Date: 8/8/17

City of Santa Barbara
Parks and Recreation Department
STREET TREE REMOVAL APPLICATION

MH
A103
PROPOSED FIRST FLOOR
AND SITE PLAN

**RESOLUTION NO. 053-15
435 E. VALERIO STREET
MODIFICATIONS
SEPTEMBER 16, 2015**

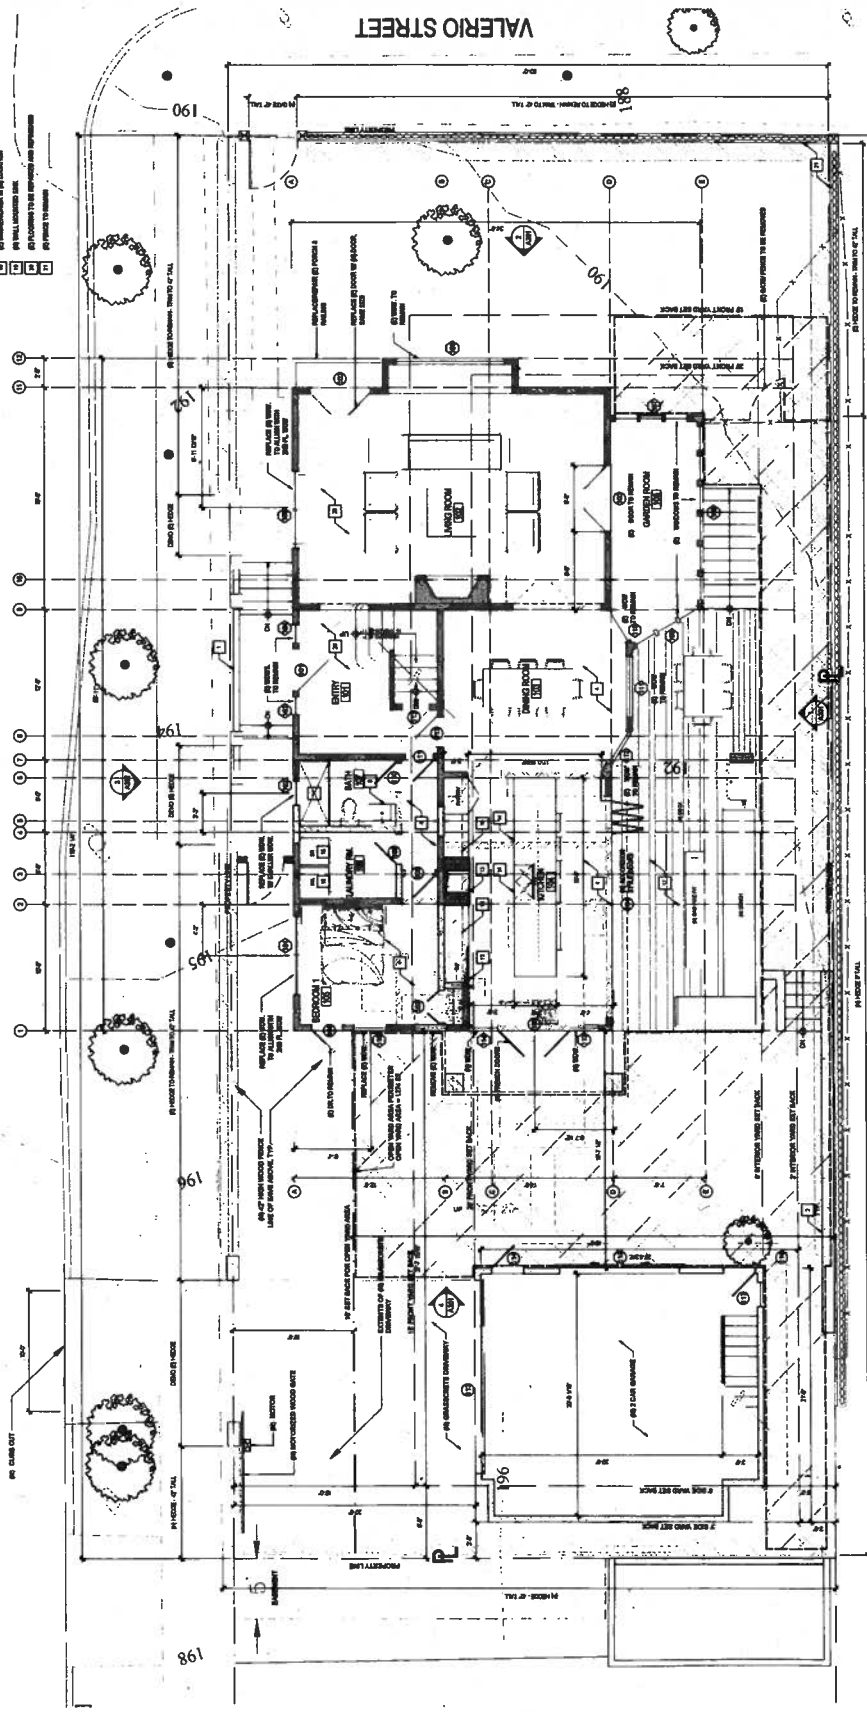
Comments: The Committee (5/0) recommends that the Commission postpone a decision until more information can be provided regarding the plans for the garage, and whether the driveway apron could be shifter to the south. Staff recommends the Commission approve the removal.

- B. Applicant shall study relocating the garage doors facing Olive Street toward the interior north property line.

- C. The proposed 10' x 7' door on the south garage elevation shall be removed. A maximum of two man doors may be located on this elevation.
